Access Compliance Report

Public Rights-of-Way

(Curb Ramps)

Intersection ID: 10015694	Main Street: IKEA_BV	Cross Street: N/A	Location: SW
ADA ID: C7FD53BED31C	Ramp Type: Perp	Initial Pass/Fail: Fail	Overall Compliance: No
Severity Score: 13.75			
Codes/Mitigation Info/Possible Solution		Field Measurements/Component Compliance

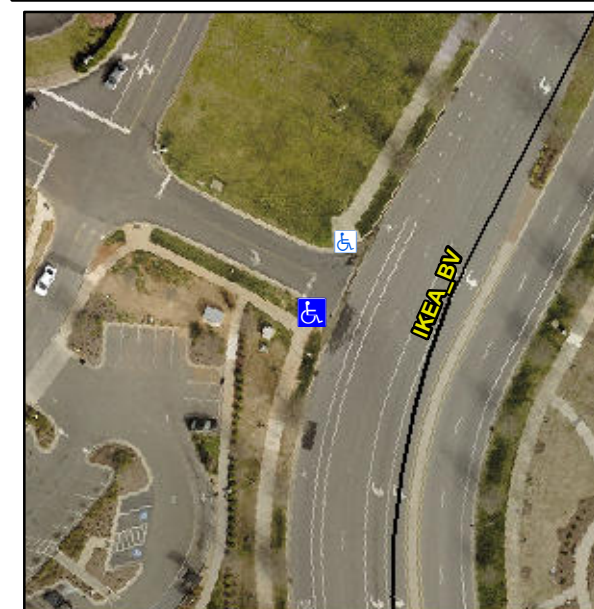
R304.2.2, R304.5.3

Compliance	Description	Data	Compliance	Description	Data
N/A	Ramp Length (in)	104.0	No	Ramp Slope (%)	9.1
Yes	Ramp Width (in)	48.0	No	Ramp XSlope (%)	3.2
N/A	Flare Type LT	N/A	N/A	Flare Type RT	N/A
N/A	Flare Slope LT (%)	N/A	N/A	Flare Slope RT (%)	N/A
N/A	Flare Traversable LT?	N/A	N/A	Flare Traversable RT?	N/A
N/A	Landing Length (in)	N/A	N/A	DWS Provided?	N/A
N/A	Landing Width (in)	N/A	N/A	DWS Contrast?	N/A
N/A	Landing Slope (%)	N/A	N/A	DWS Length (in)	N/A
N/A	Landing X Slope (%)	N/A	N/A	DWS Full Width?	N/A
N/A	Landing Curb? (Y/N)	N/A	N/A	DWS Offset (in)	N/A
N/A	Shared Landing?	N/A			
N/A	Gutter Ponding?	N/A	N/A	Gutter Slope (%)	N/A
N/A	Gutter Lip Ht (in)	N/A	N/A	Gutter X Slope (%)	N/A
N/A	Painted X Walk1?	No	N/A	Painted X Walk2?	N/A
	X Walk 1 Direction	To N		X Walk 2 Direction	N/A
N/A	X Walk 1 Width (in)	N/A	N/A	X Walk 2 Width (in)	N/A
	X Walk 1 Slope (%)	0.1		X Walk 2 Slope (%)	N/A
	X Walk 1 X Slope (%)	1.2		X Walk 2 X Slope (%)	N/A

Remove & Replace Entire Ramp.
